Addendum No. 1

Bid Opportunity: 7159-RW-22 – Smithson PS Office and HVAC Upgrades.

Closing Date: Monday, March 14th, 2022 2:00 PM

2 PROPOSED EQUIPMENT LAYOUT - BOILER ROOM

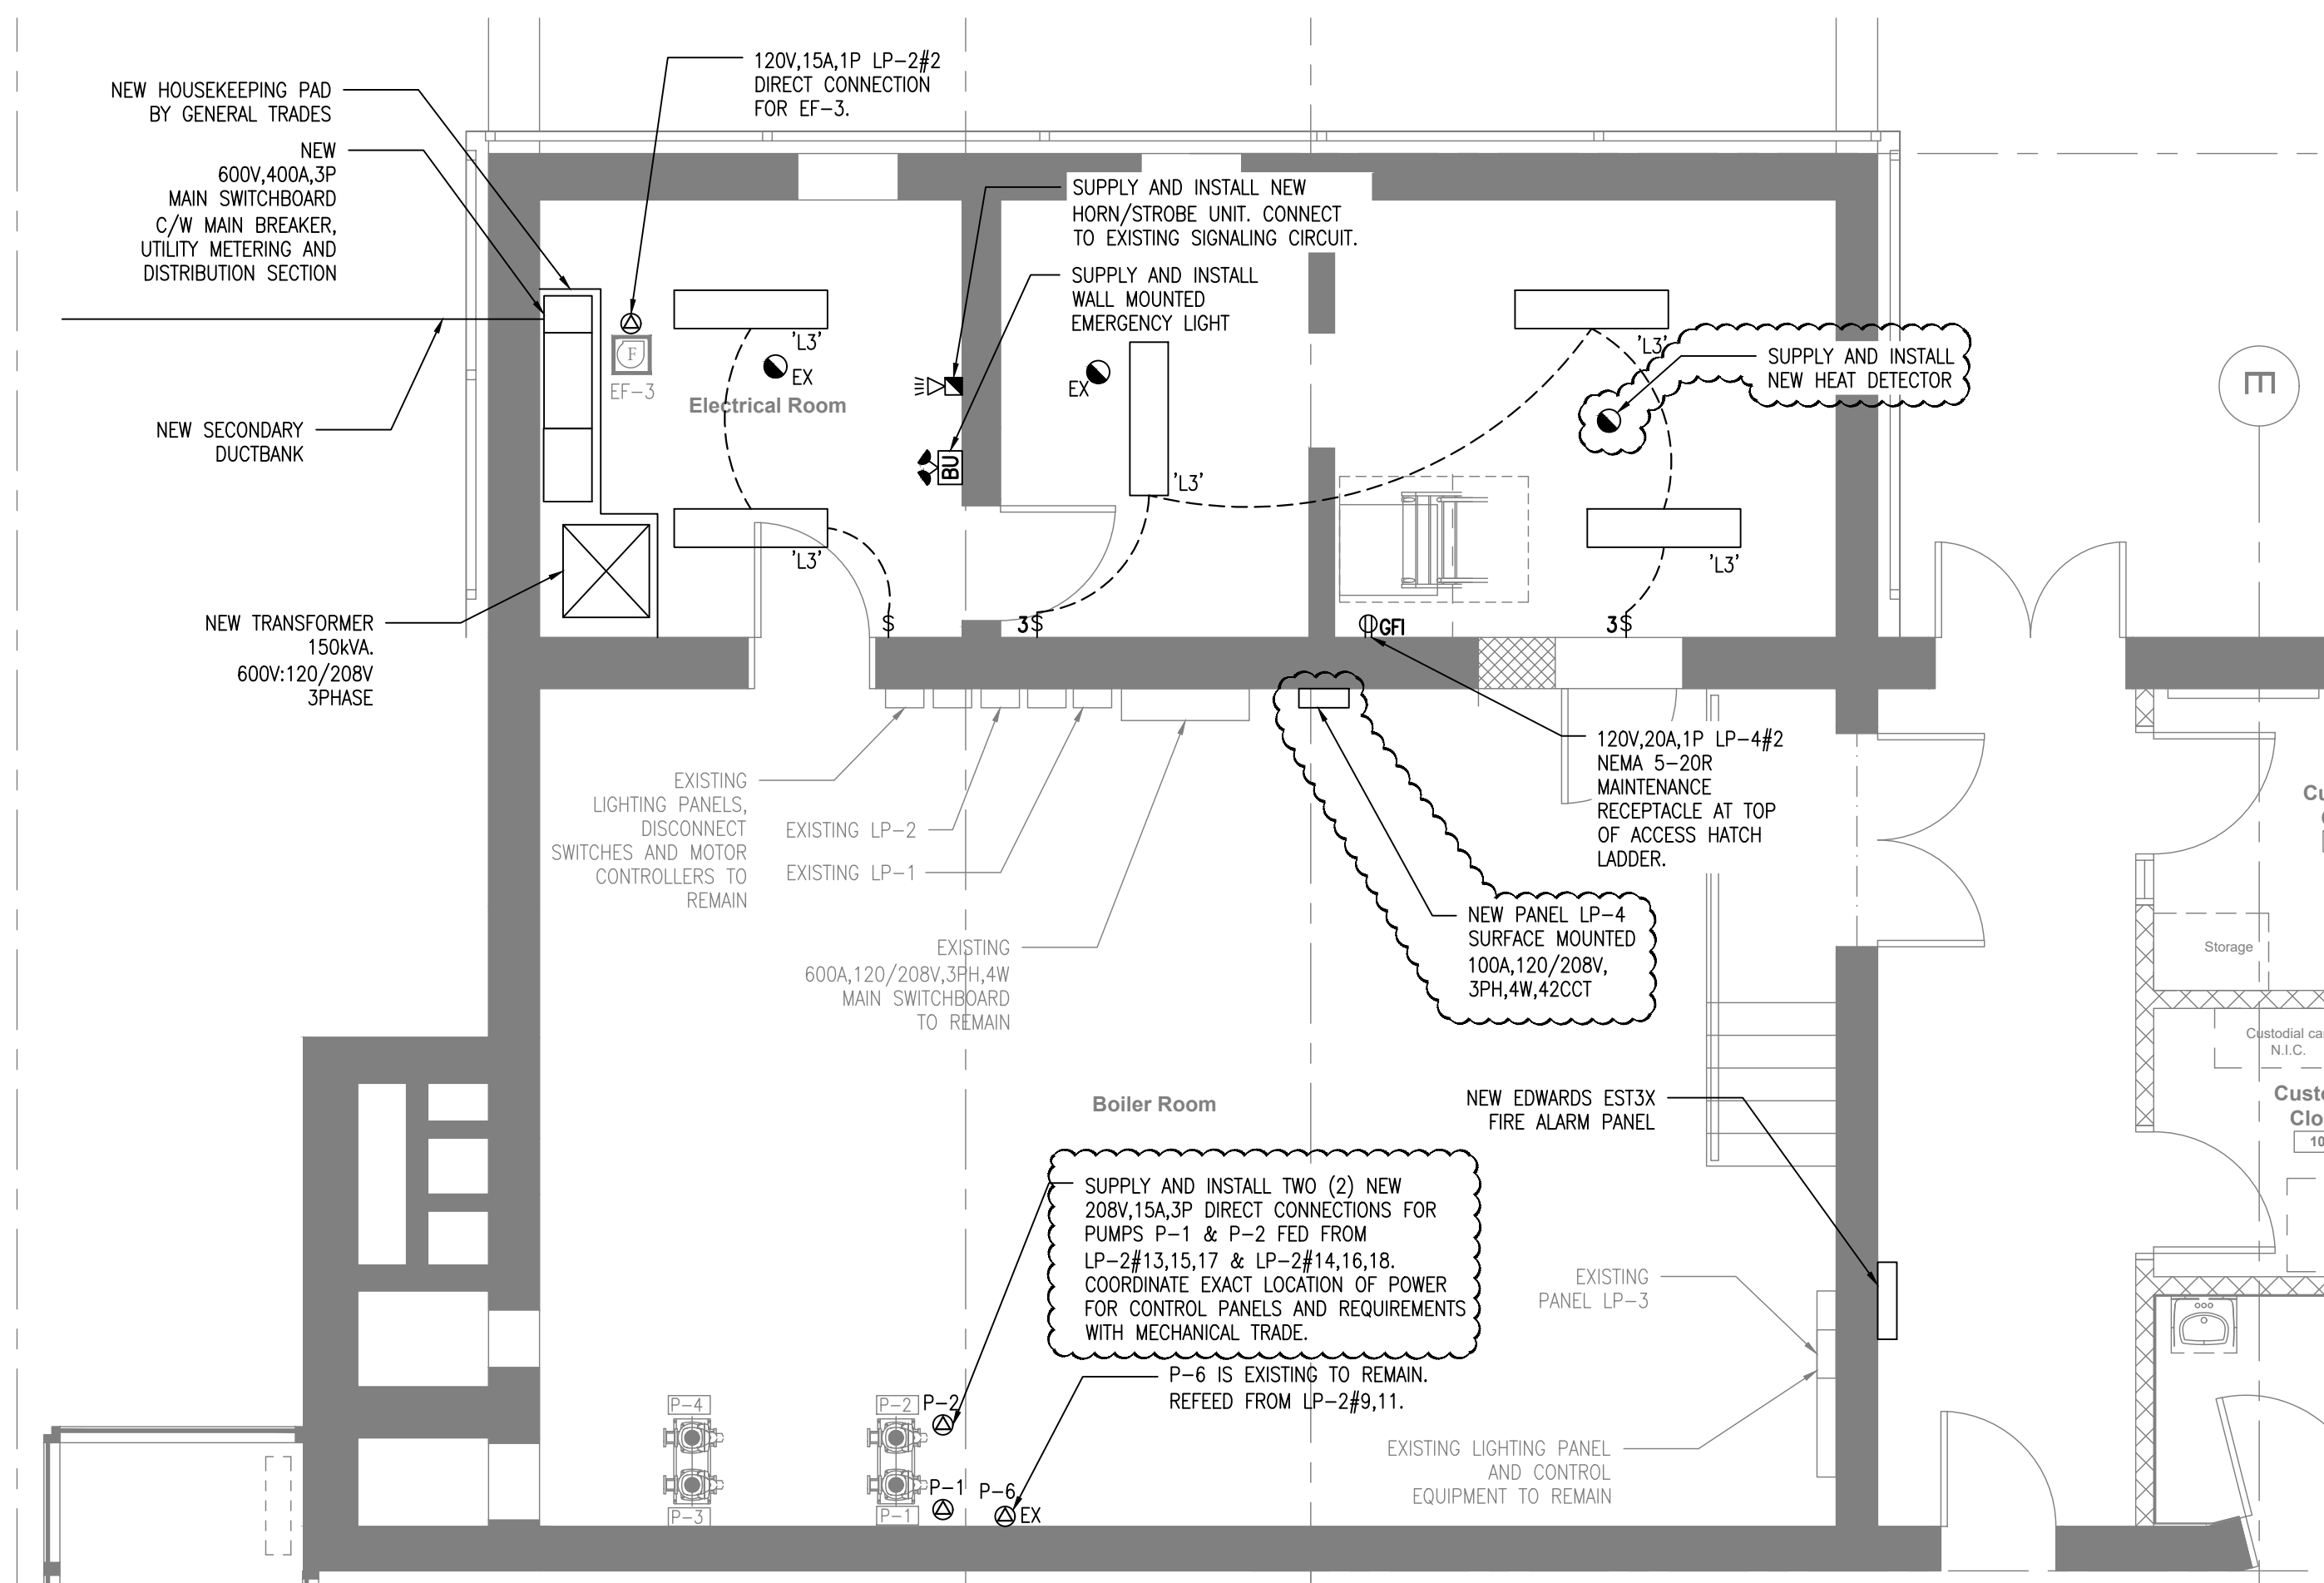
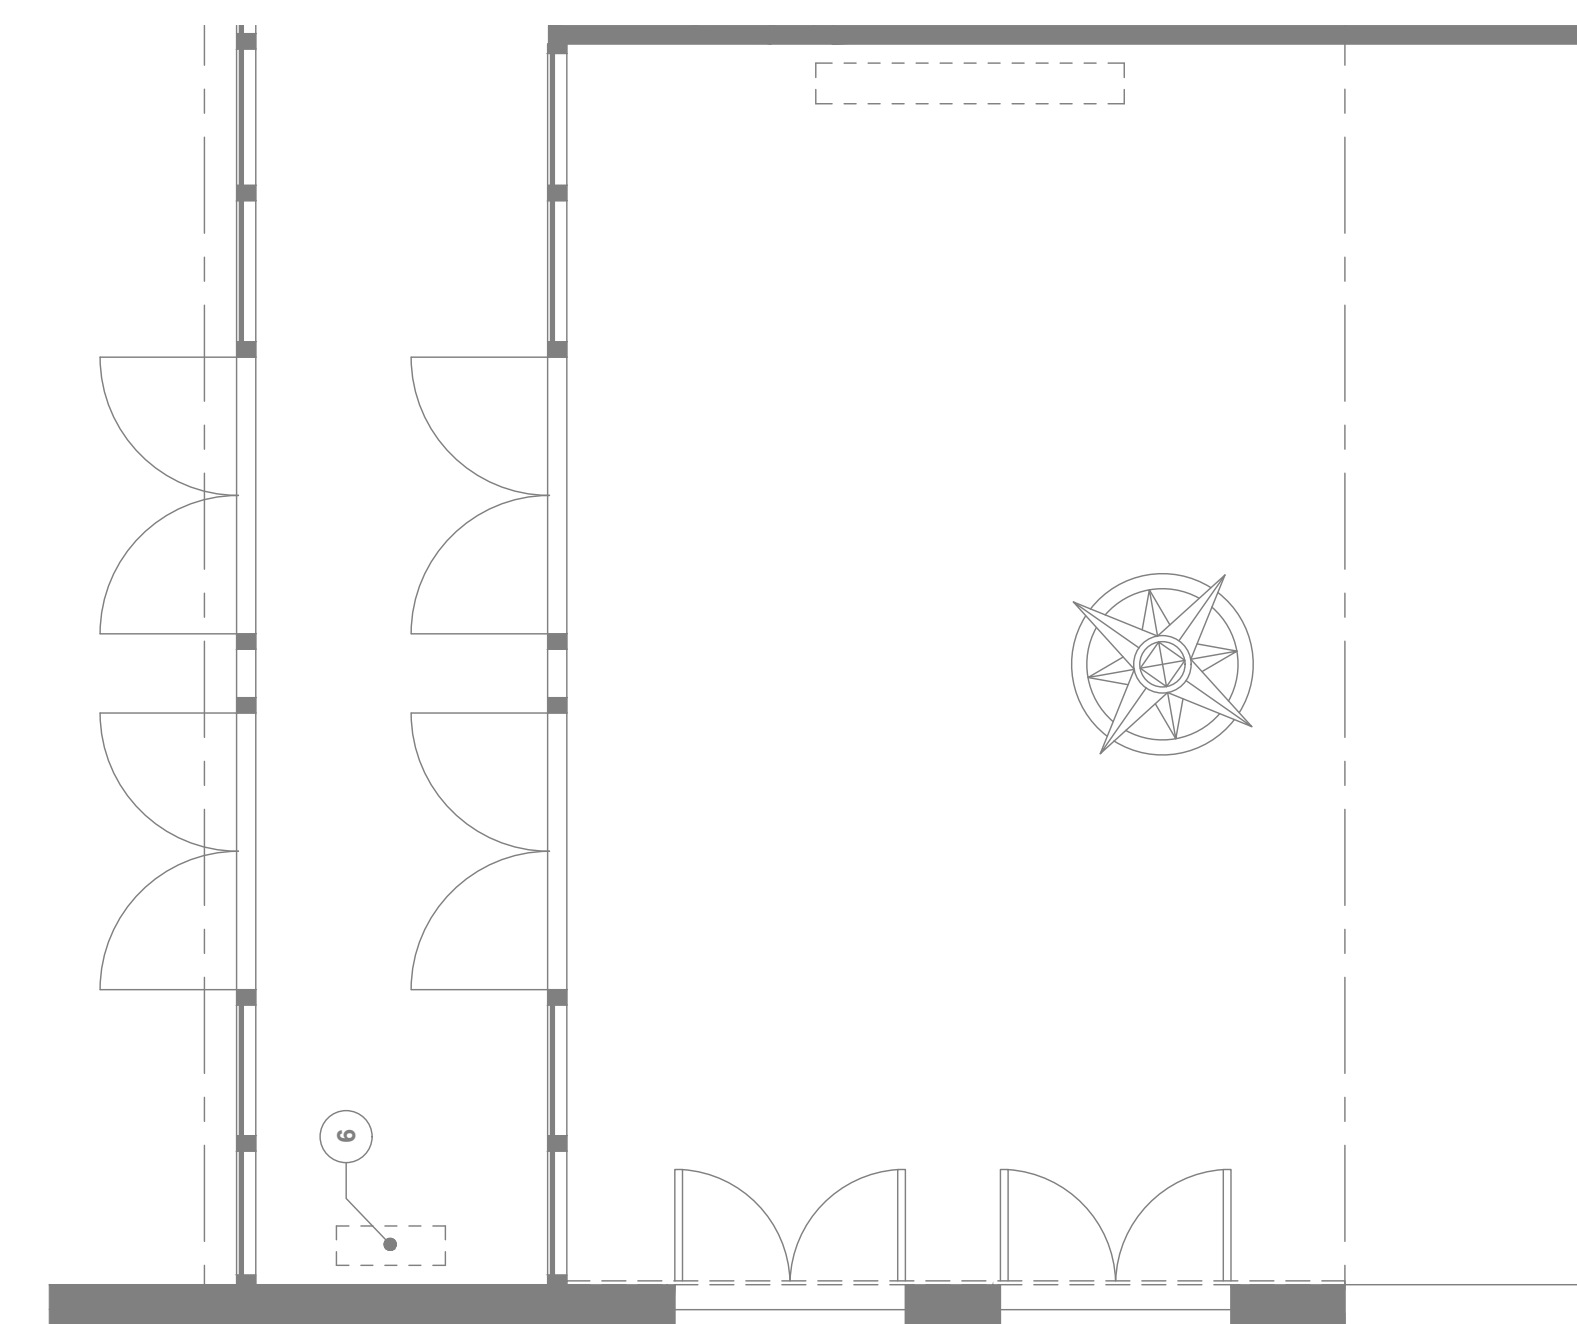
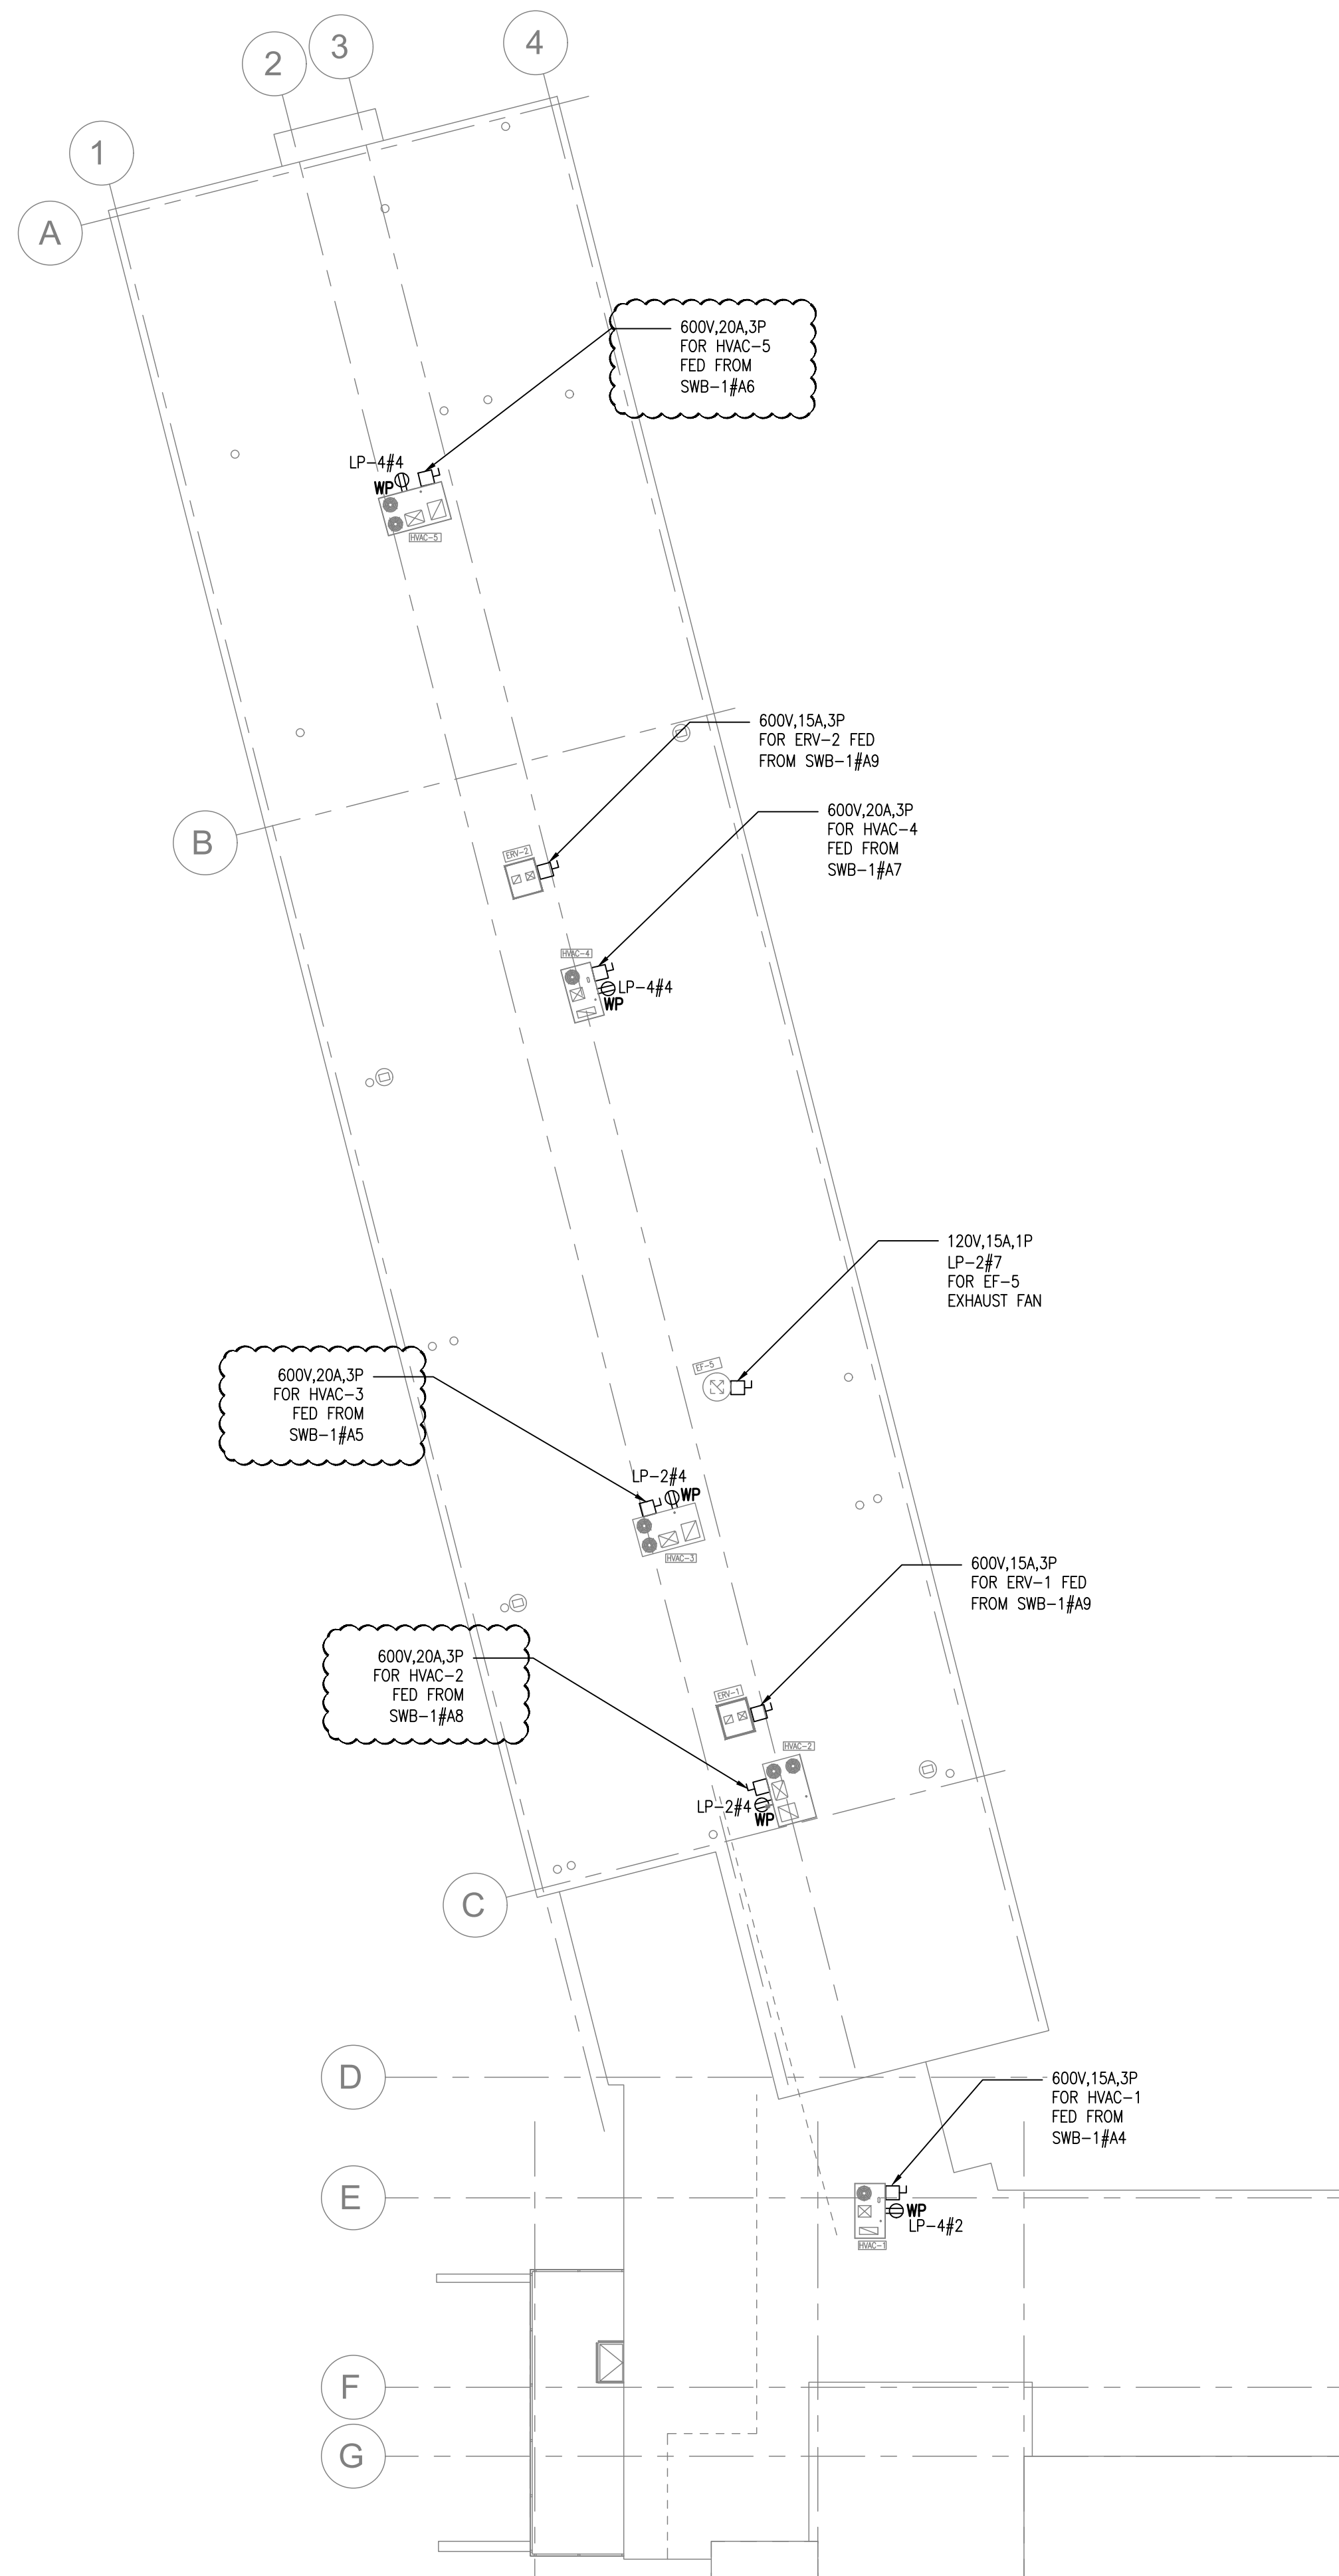
8. REFERENCE DRAWING E9 – ELECTRICAL AND BOILER ROOM LAYOUTS (ISSUED FOR ADD-E01)

1. Heat detectors in the electrical room and adjacent storage room are existing to remain. The supply and installation of an additional heat detector has been added to the existing utility vault that is being revised to a storage room.

2. Panel ‘LP-2’ is now existing to remain. Revise breakers and feeds as shown and supply and install new breakers as required.
3. The supply and installation of a new 100A,208V,3ph,4W panel ‘LP-4’ has been added within the boiler room. Refer to drawings for additional information and panel schedule.

4. Locations of existing electrical panels within boiler room have been provided for reference.
5. Notes 1 & 2 have been revised to provide clarification regarding the annunciator installation. There is no existing annunciator for the fire alarm control panel, therefore its demolition is no longer part of the scope of work. The new annunciator panel shall be supplied and installed in the main entrance vestibule.

7. Detail 3/E9 has been added to show the proposed location of the new Annunciator panel. Exact location is to be coordinated onsite with WRDSB before rough-in is completed.
8. The power supplies for Pumps P-1 and P-2 have been revised from 600V,15A,3P to 208V,15A,3P. The pumps will now be fed from LP-4.

10 TOPCAT AND PROJECTOR ROUGH-IN DETAIL
E11.1 SCALE: N.T.S.

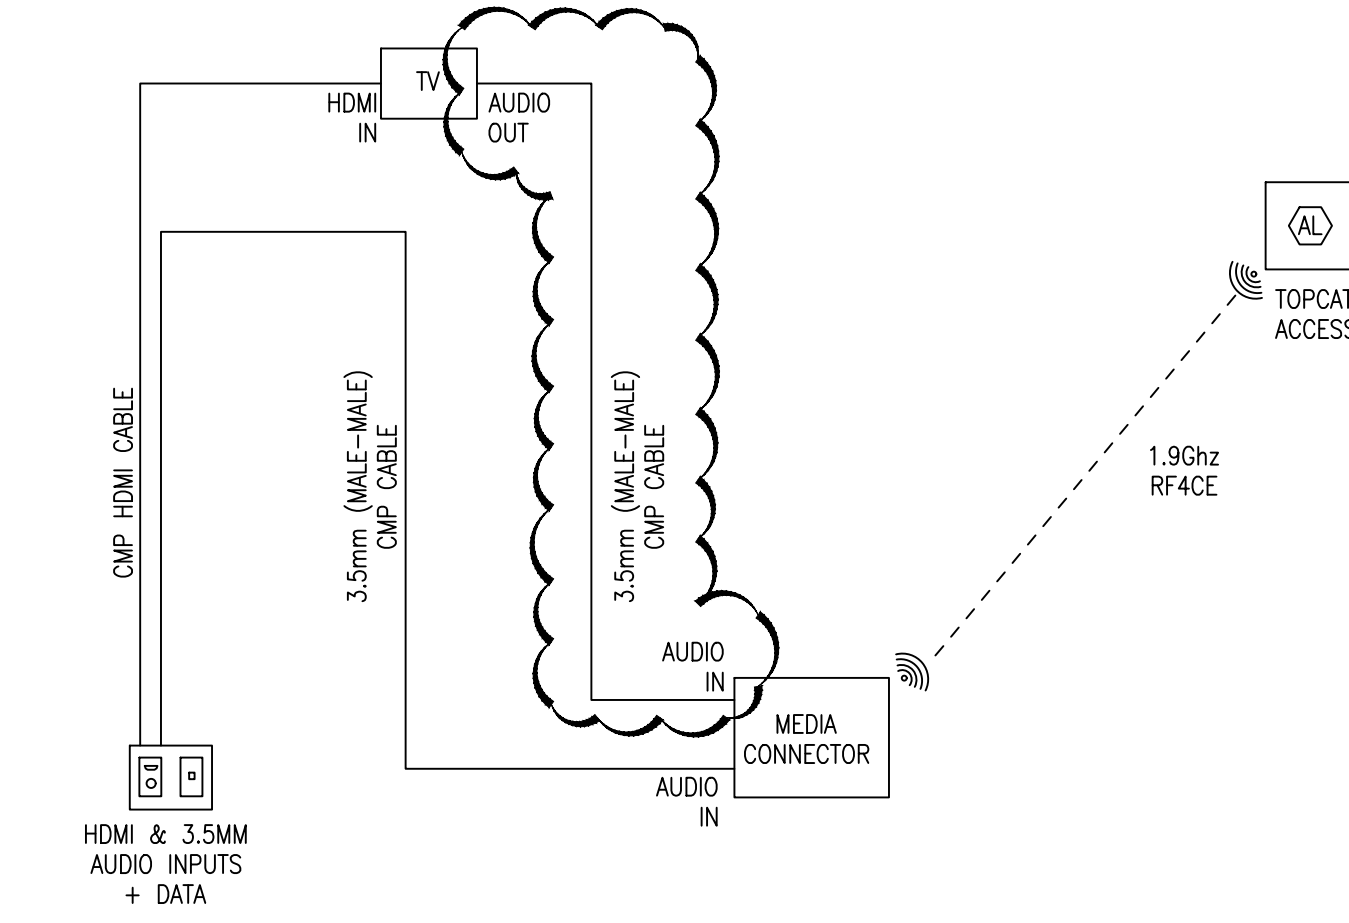
1. Updates have been made to details 10/E11.1 and 11/E11.1 to add a 3.5mm Audio cable from TV to Topcat Audio system for TV audio output.
